In the United States Patent and Trademark office

In Re application of::)	Date: March 13, 2006
Carlos Daniel Jaffe)	Group art unit: 3732
Serial number 10/632,505)	Examiner: Candice Capri Stokes
Filed: 08/04/2003)	
For: All-in-one prophy angle)	
)

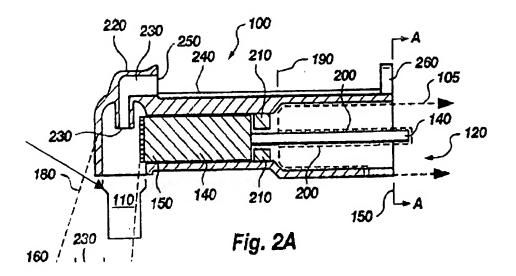
As to claims 2, 11 and 20 it is submitted that "Chipian disclose the prophy cup 40 slightly flaring in its fill length; but, no definable skirt at the outer edge" (page 6, 1st paragraph).

Claims 2, 11 and 20 state: "flares outwardly towards the front end, the front end is used for polishing teeth". Note in claim 1, lines 4-7 " dental prophy cup with a longitudinal axial direction, a rear end and a front end with a front polishing portion..". In Fig. 2A below the axial direction is vertical with the cup back end, with the annular tip, at the top mounted to the handpiece the front end facing downwards. The **front end** of the prophy cup is **always used for polishing** the teeth. Do not confuse the front end of the prophy angle with the front end of the prophy cup.

. The limitations of the amended version of claims 2,11, and 20 are met by the Chipian et al reference

because Chipian et al disclose the front end of the prophy cup flaring outwardly toward the front end,

Regarding claims 3,12, and 21 Figure 2A of the Chipian et al reference (also reproduced below) does show an annular lip "within the inside of the prophy cup" as recited in the claims.

As discussed above, the front end of the prophy cup is downwards away from the prophy handpiece. The front end of the prophy angle is on the left and should not be confused with the front end of the prophy cup. Chipian does not disclose the front end of the prophy cup flaring.

The claims do not state an annular lip "within the inside of the prophy cup". The claims state: "an annular retaining lip defines the inside of the front end of the prophy cup". Chipian in Fig. 2A disclosed an annular lip on the outside of the back end of the prophy cup. Fig. 2A does not disclose the inside of the prophy cup. Chipian does not disclose the annular lip within the prophy cup.
